Whitworth Street Planning Comparison

Since planning approval in 2016 the site has been purchased by Vision Manchester Limited. The client has engaged a full design team and RussellWBHO to update the detail design to the required regulations, agree a building contract and construct the development. Through this process a number of design changes are being proposed.

This updated document is being presented to Manchester City Council Planning Department to illustrate and explain the nature and extent of the proposed changes and to seek the Council's formal approval through the necessary planning process.

3.8 Proposed Typical Lower Floor Plan
(4th - 14th)

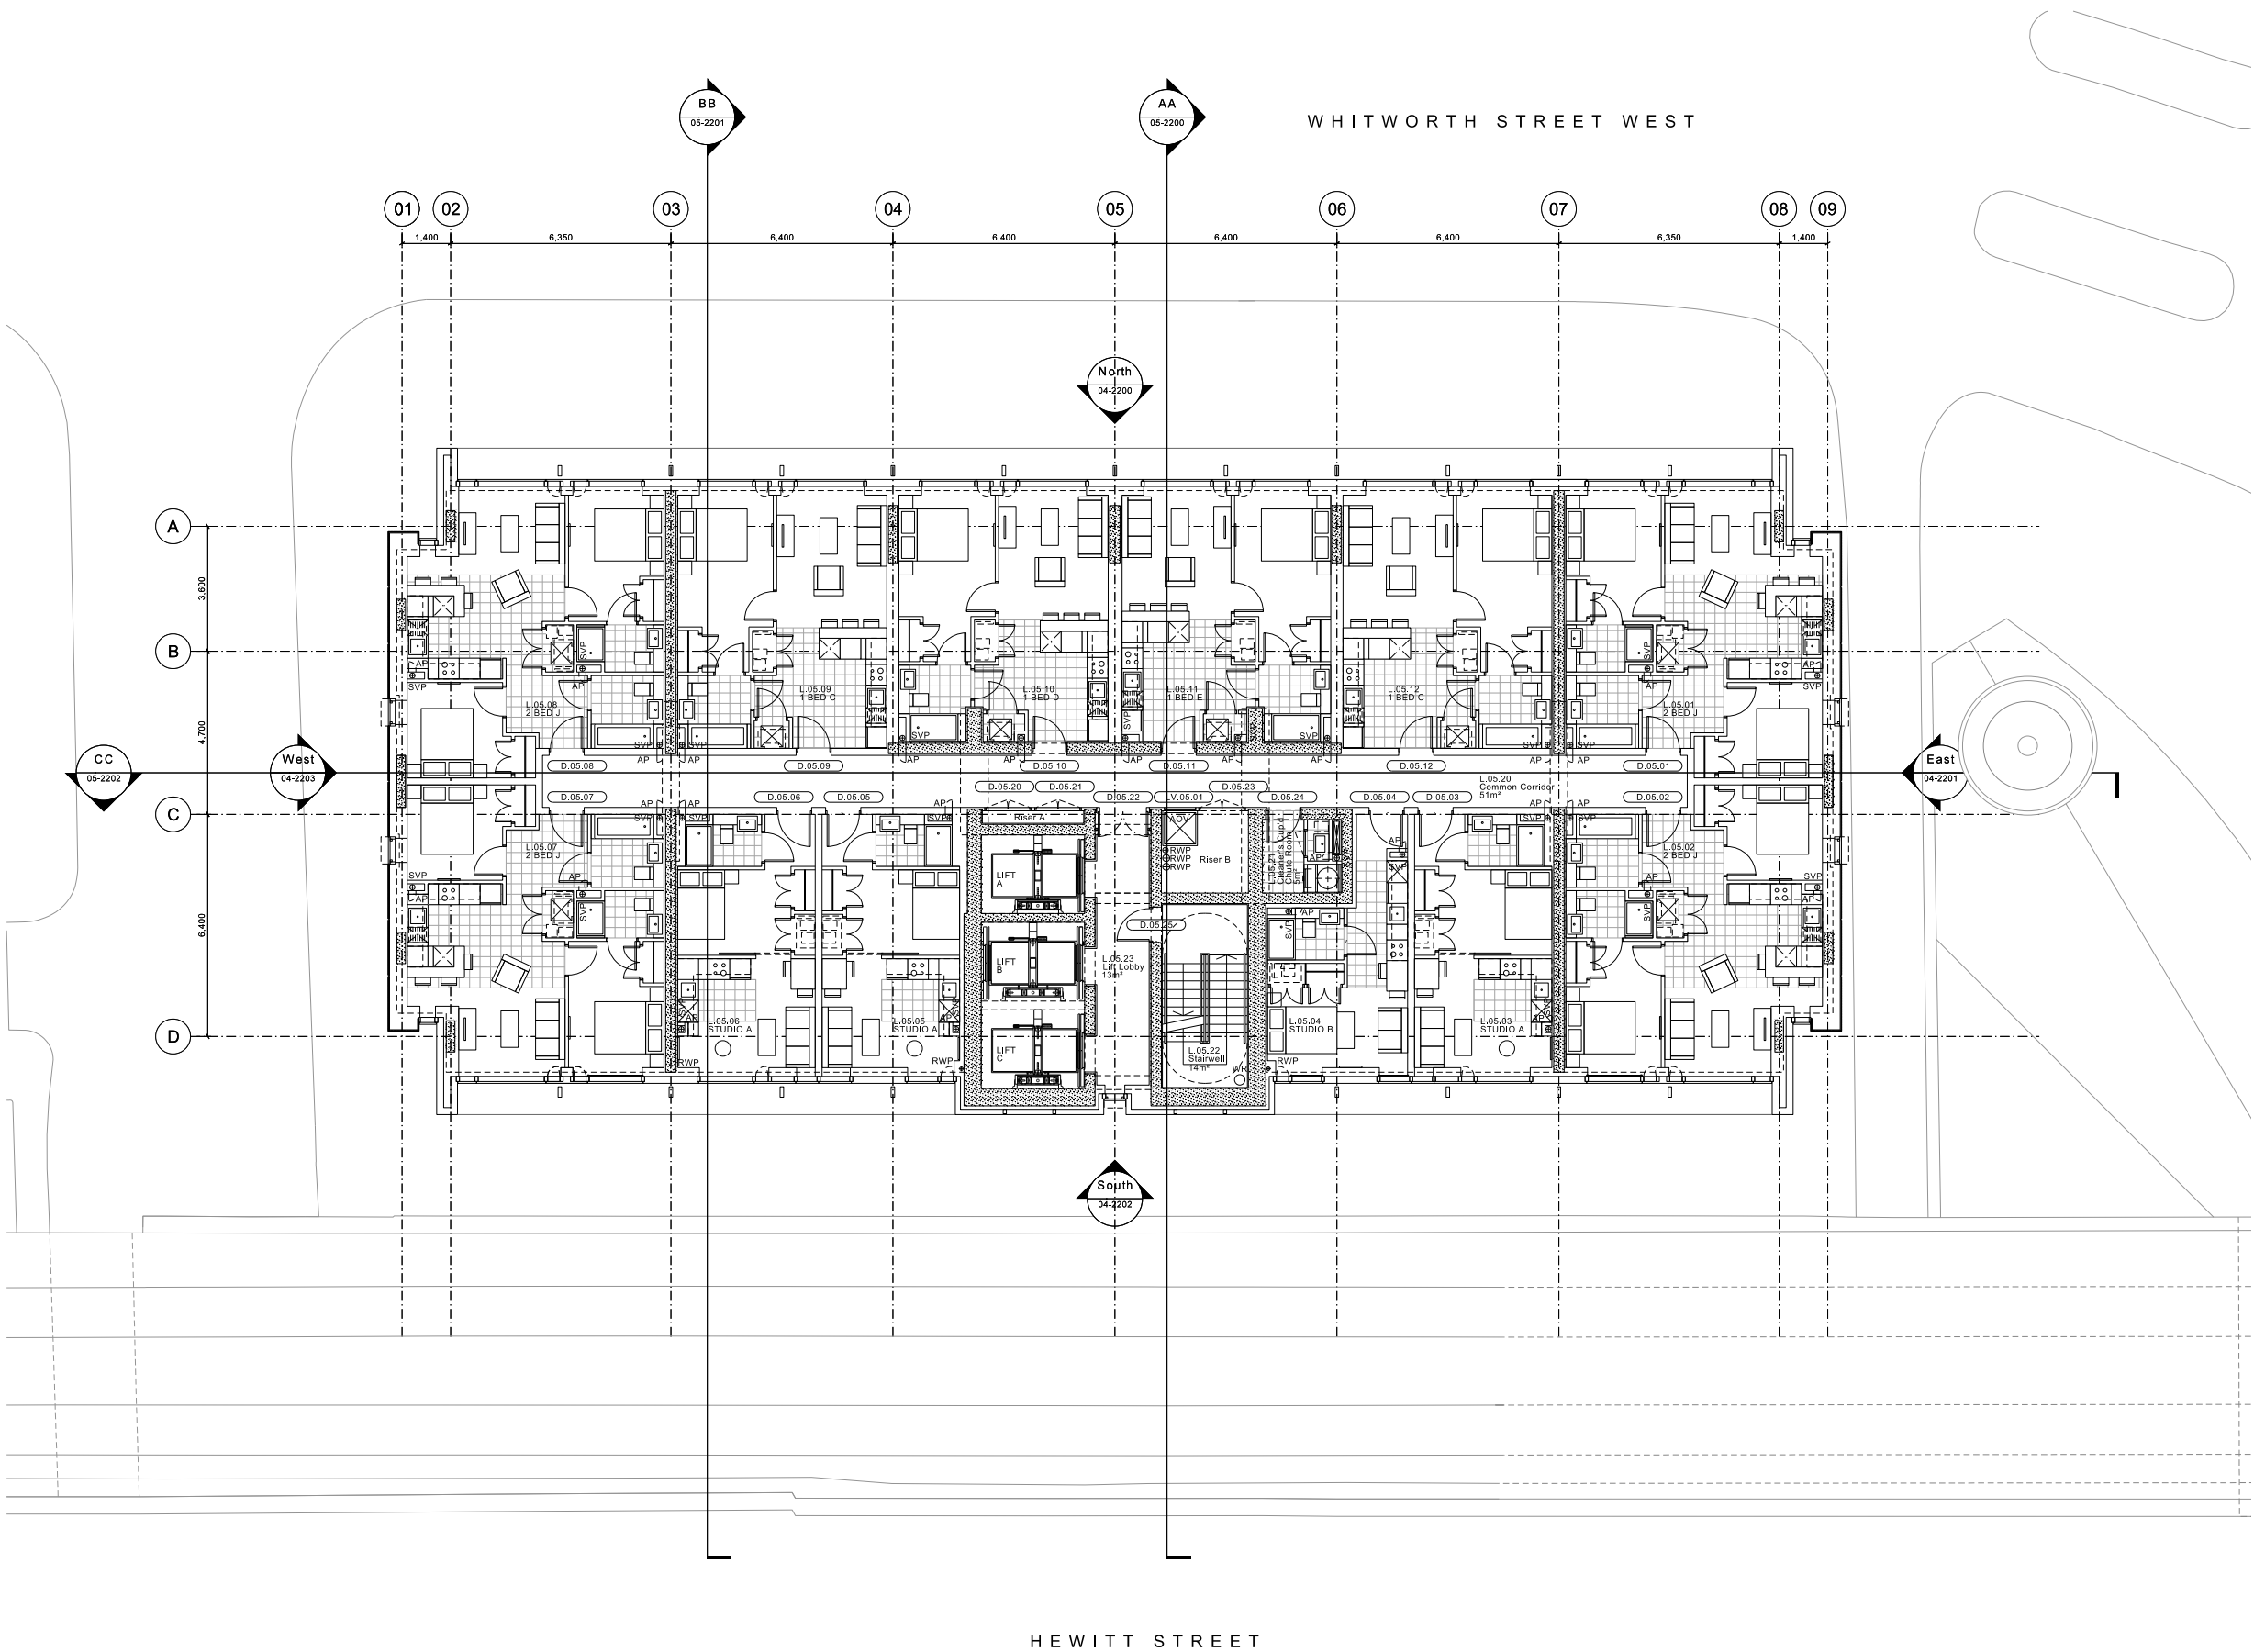
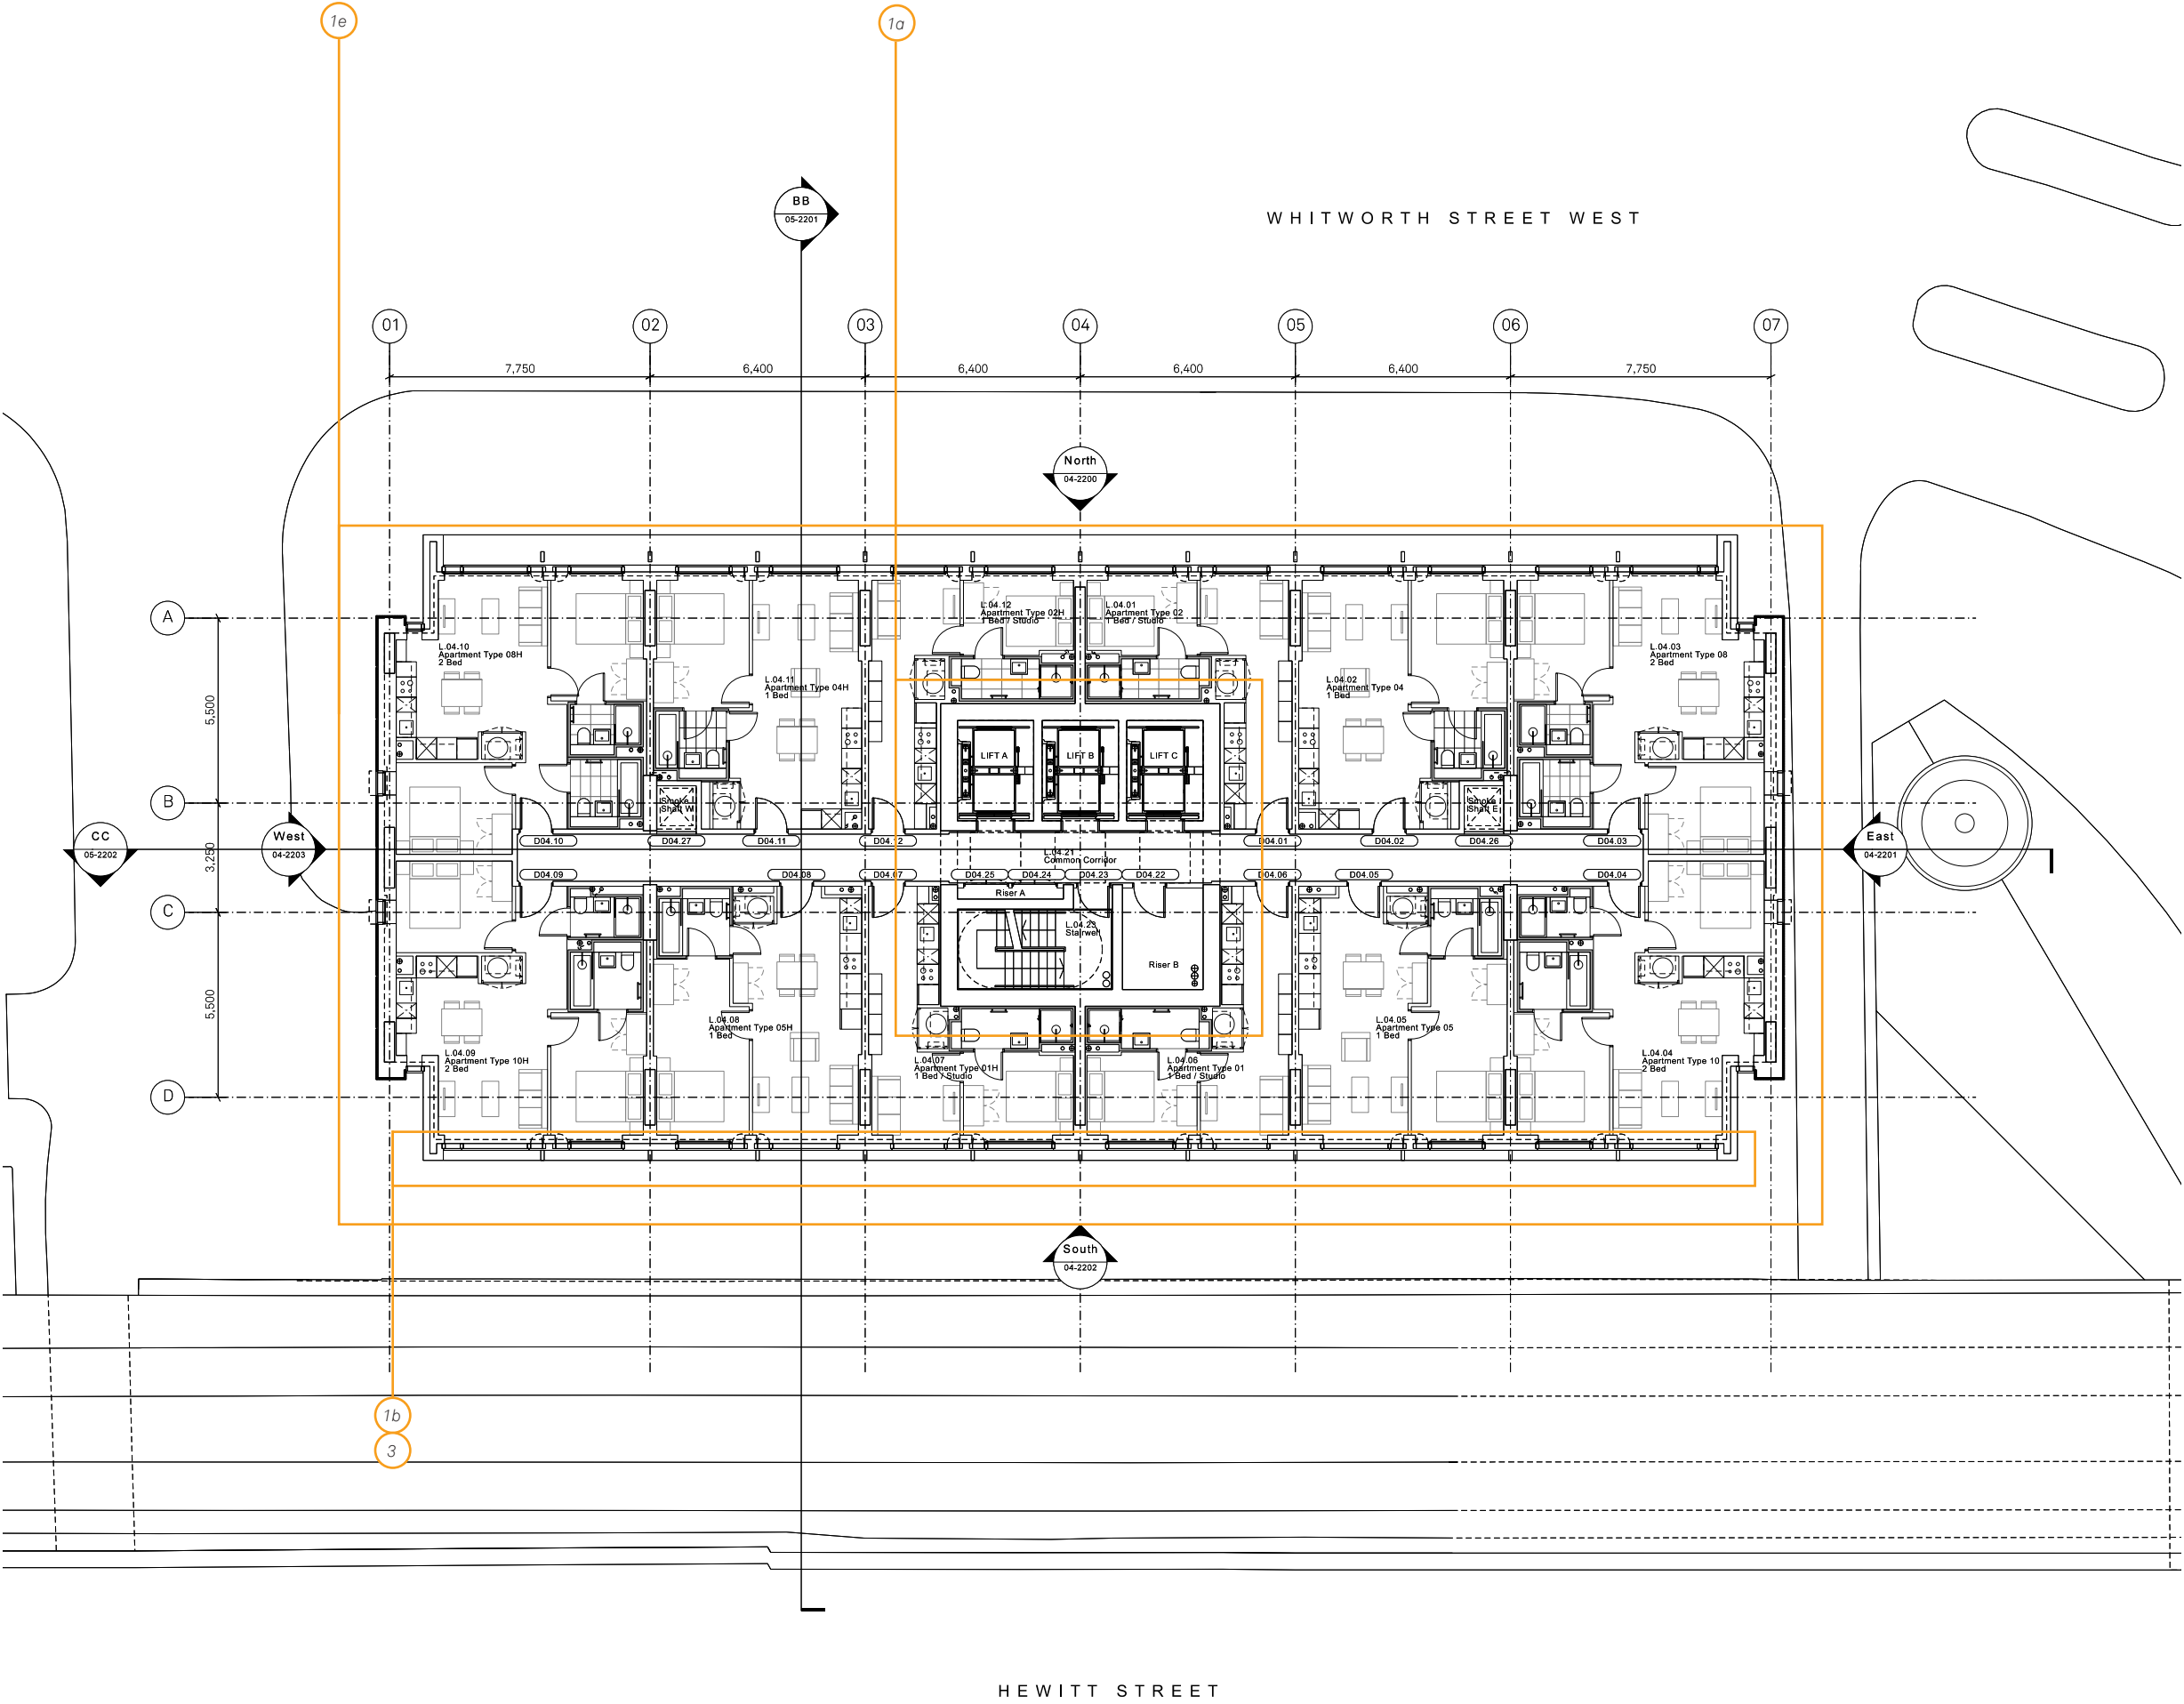
- 1a - Core Repositioned
- 1b - Main body of south facade to match north facade
- 1c - Entrance relocation
- 1d - Form of roof pavilion
- 1e - Apartment & amenity layouts
- 1f - Inclusion of commercial unit & dedicated entrance
- 2a - Reduced floor to floor heights
- 2b - Additional floor
- 2c - 2 no. Guest Beds & 2 no. 1 Bed become 2 no. 2 Bed & 2 no. 3 Bed
- 3 - South 'picture frame' reveal depth reduced by 600mm
